IEEE P802.11
Wireless LANs

Comments received on 802.11b in Letter Ballot 16

Date: January 9, 1999

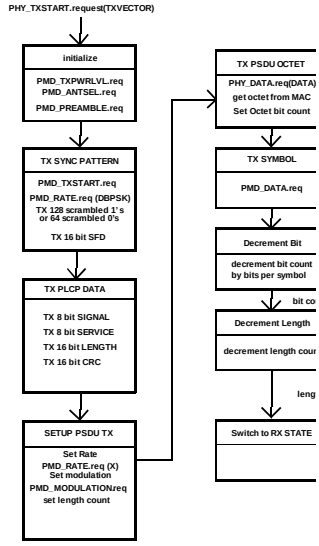
Seq. #	Clause number	your voter's id code	Cmnt type E, e, T, t	Part of NO vote	Comment/Rationale	Recommended change
1	1.2.5	ca	E	N	The figure 8 needs to be modified for the LONG/SHORT PREAMBLE

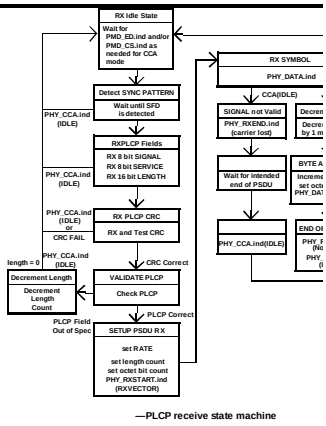
2	1.2.6	ca	E	N	The Receive state machine needs to have the set RATE mechanism modified
